Re: Agenda Item 10-A (Henry Weyse/Charles Morris House)
Certificate of Appropriateness 20ENT-0160 for new door and fencing
City Landmark (LC-05-041) and Landmark Parcel (17ENT-0077)
Address: 401 Ocean Avenue
Owner/Applicant: 401 Ocean Avenue, LLC (Mark Tabit)
Our File No. 22452.001

401 Ocean Avenue
Project Design Modifications – Front Door for South Unit

401 Ocean Avenue
Project Design modifications – New fencing

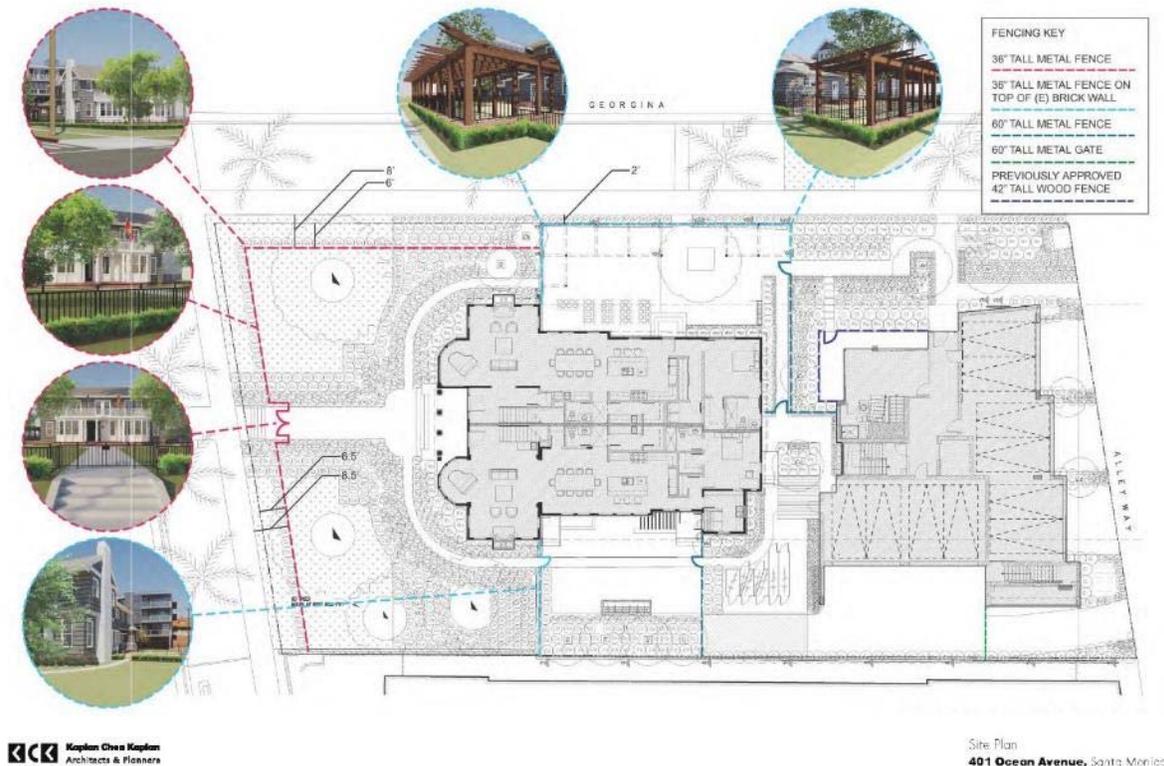
The application seeks approval for a metal picket fence with narrow ½” square pickets with wide 4” spacing between each picket. The height of the fence would be only 3’ in the front yard and 5’ in the side yards on both sides of the Landmark.

West elevation with proposed door located in place of window

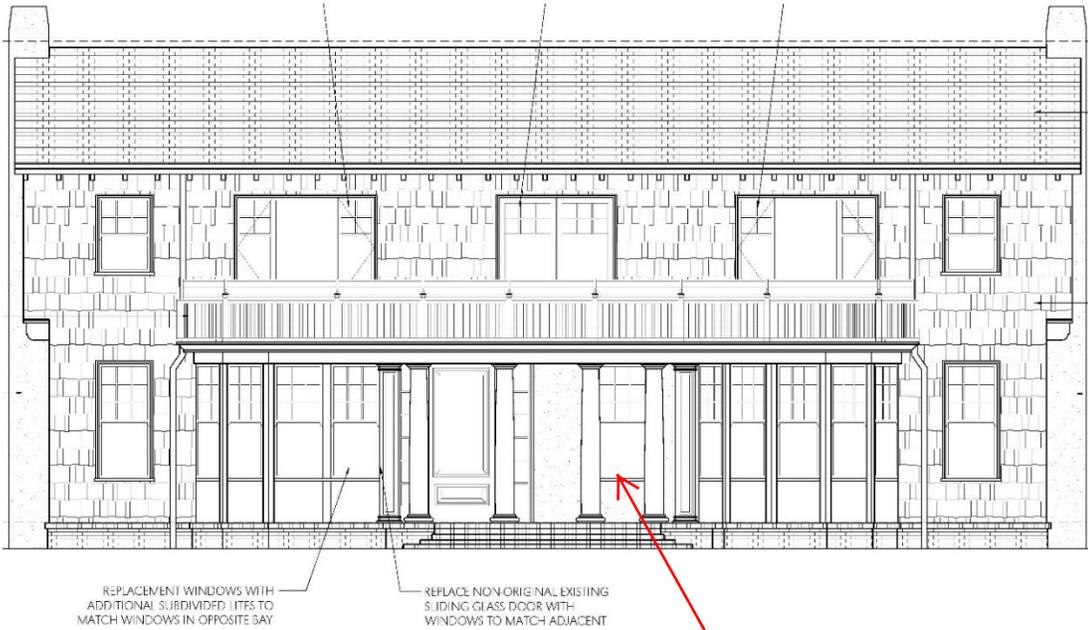
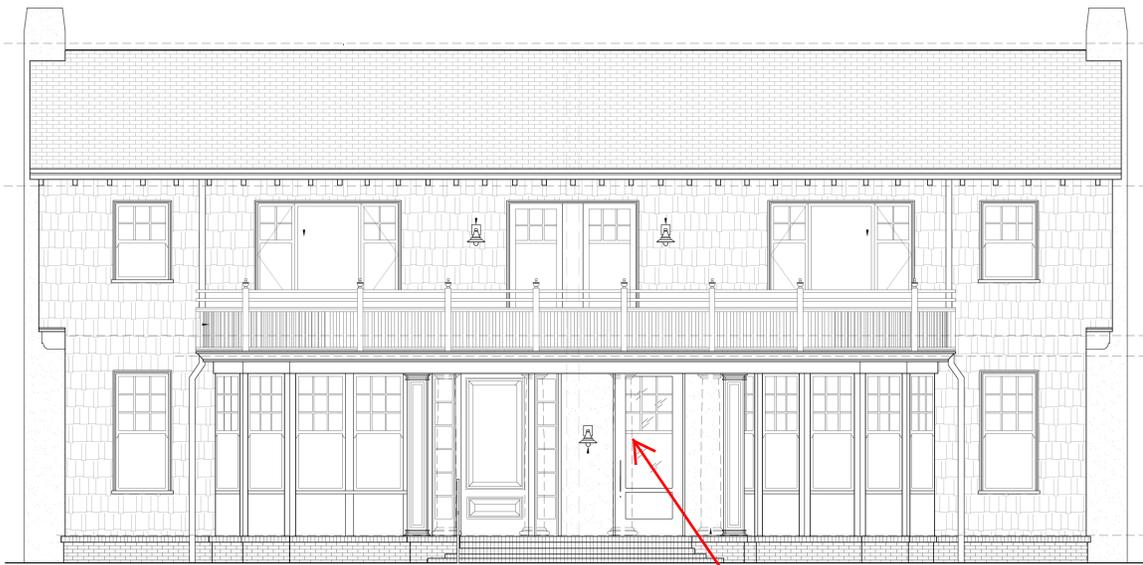
The front porch is covered by a large balcony that extends along most of the front façade. The existing front door is not centered in the front porch; rather, it is located off center to the north and is recessed beneath the second floor balcony. In approving Certificate of Appropriateness 18ENT-0142, the Santa Monica Landmarks Commission approved an operable window in the southern portion of the front porch that serves the south unit. The design of this new window follows the design of the adjacent front façade windows (existing) with 9 divided lites in the upper sash. We are proposing to replace that approved new window with a wood door in that same location. The design of the proposed door would be similar to the approved window design in that it is the same location and height with the distinctive 9 lite window division in the upper portion matching the adjacent windows. This proposed door will serve as a front door for the south unit.

The proposed door will not impact the overall appearance or historic character of the building. The view of the front entry is dominated by the second floor balcony and the row of one foot diameter columns and protruding pair of bay windows, as well as extensive surrounding white trim. The front entry door is recessed well within the porch and is not particularly prominent, except as to color. The north unit's existing front door is designed as a deep color that stands out against the white back wall. The proposed additional front door will be painted white to match the color of the adjacent wall and windows and will retain the upper glazing with 9 lites so the overall configuration and appearance will be similar to the approved window that it will replace. The design of the proposed second front door to the south unit is distinct from the north unit's original solid wood entry door with sidelights and will appear less like a front door and more like a secondary or porch door but still provide the south unit with a front entry to the main living space on the ground floor of that unit with a direct connection to the front yard on Ocean Avenue in this prestigious location.

DOOR ELEVATION

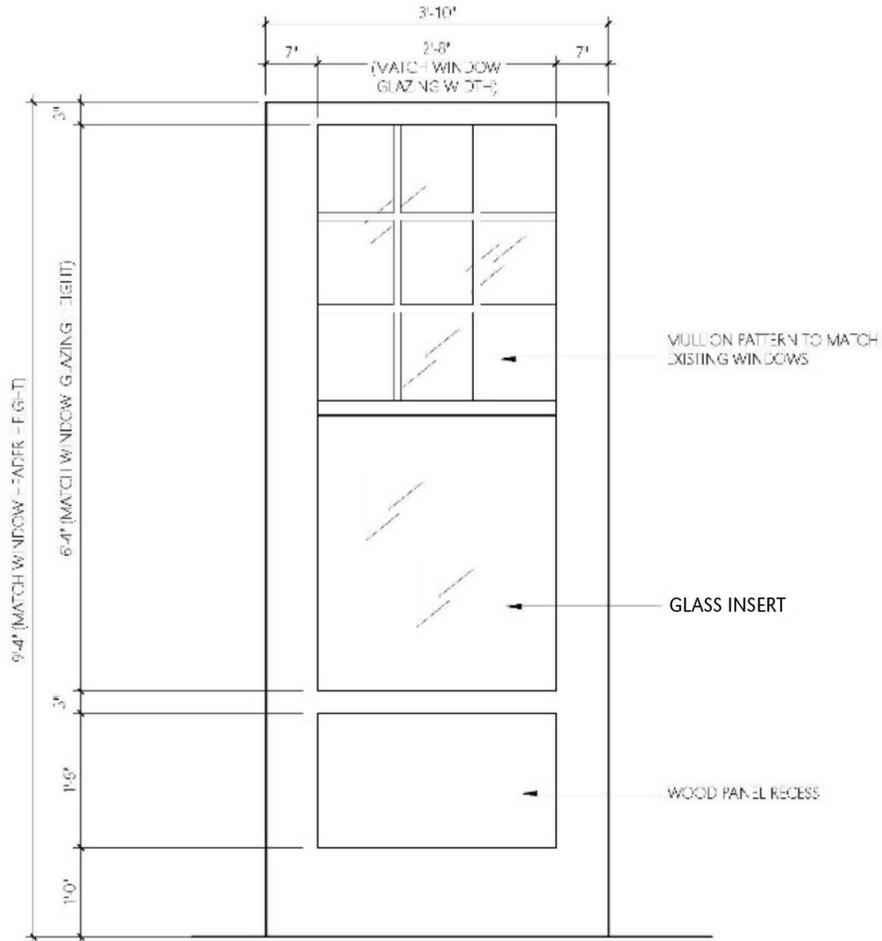
Proposed door at front porch – door painted white to match wall and window trim

TYP. FENCE SEGMENT ALT 2
 SCALE $\frac{3}{4}" = 1'-0"$

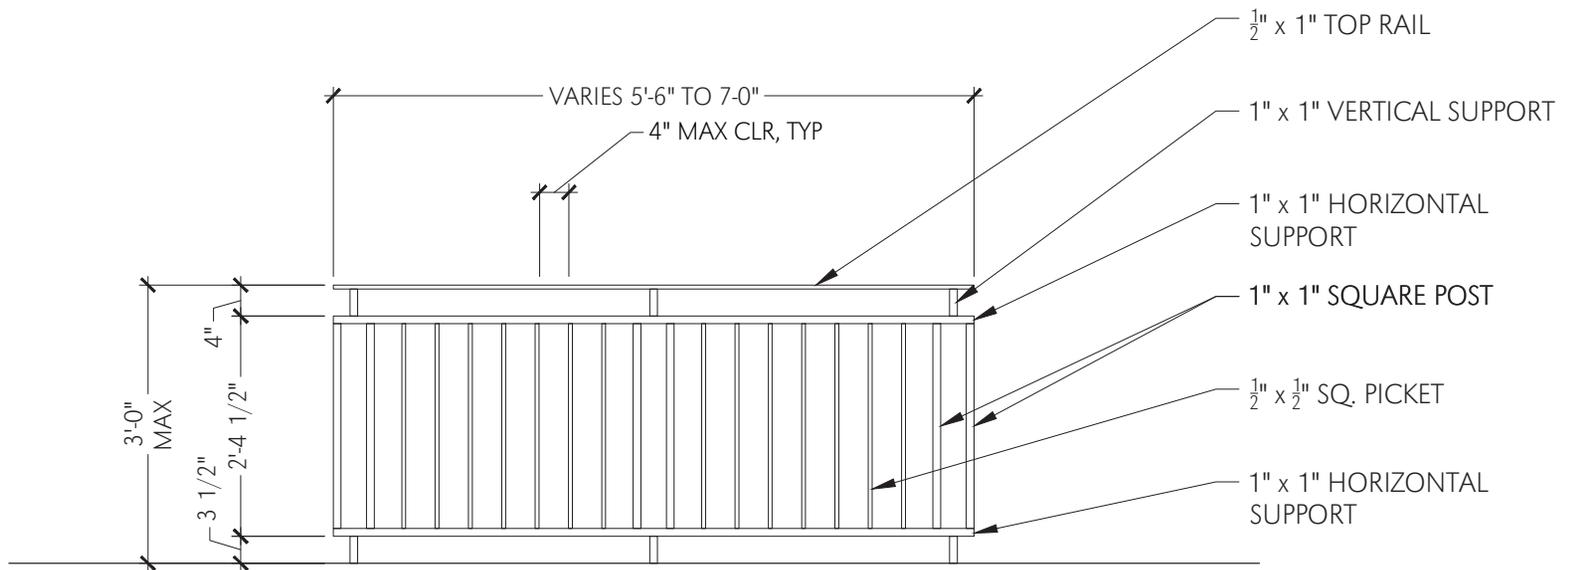
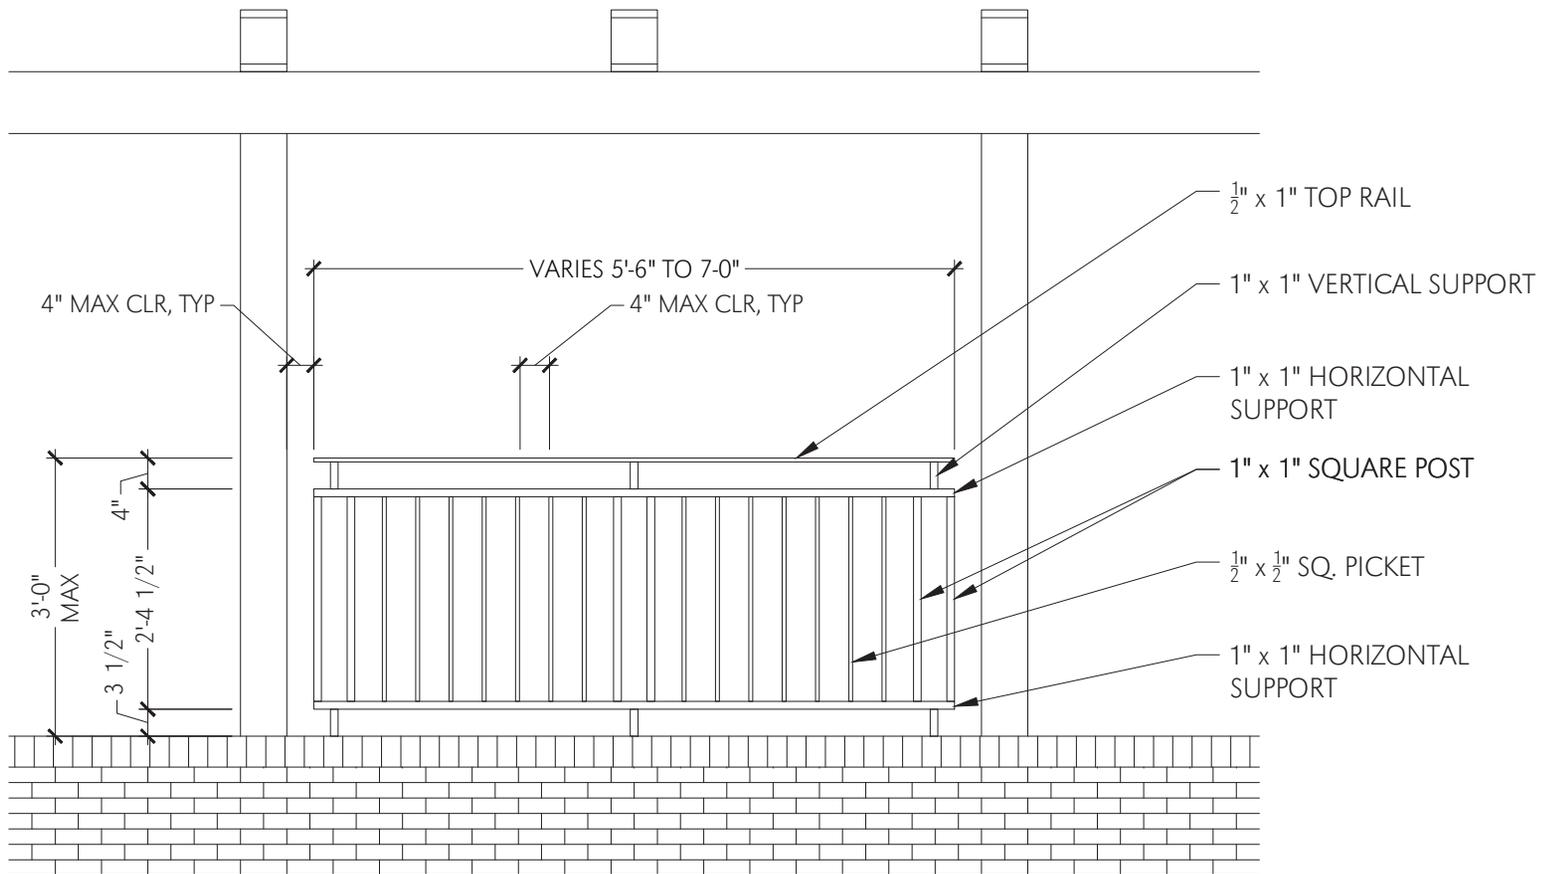
The proposed fencing will not alter any site grading or features and follows the crest of the front yard slope. The original front steps will remain in place and the fencing will include a low-profile entry gate at the top of the steps. The fencing has been designed to be open and for the most part transparent so as not to block public views of the residence and its associated landscape. The fencing is setback from the sidewalk and preserves the original sloping grade. The metal fencing will have a simple design compatible with the historic residence and an unobtrusive appearance that will not in any way compete with the landmark building's design features. The pickets are 1/2" square at 4" and 2" spacing, the horizontal bars are 1/2" x 3/4" deep and the posts are 2' square spaced approximately 6 feet.apart all painted black

The low fence will continue around the north side of the property at the crest of the slope along Georgina Avenue to connect with the refurbished low brick wall at the pergola along the side yard. At that point the metal picket fencing will be added atop the brick wall between the pergola columns along the street side for a total height of approximately 5 feet to provide a light layer of security for the private sideyard outdoor space on the north facing Ocean Avenue east of the main building. The metal picket fencing will continue between the wood columns of the pergola and then wrap back at the east end towards the rehabilitated residence at the 5 foot height. The fencing continues to the south into the site and will join a cross fence deep inside the property to complete a secure enclosure for the residents of the condominiums. A 5' fence is also proposed to secure a private yard on the south side of the rehabilitated landmark residence that would be appropriately setback east of the front massing of the historic building. These fences are internal to the site and intended to be as unobtrusive as possible and will not compete with or alter any historic feature of the site and rehabilitated building.
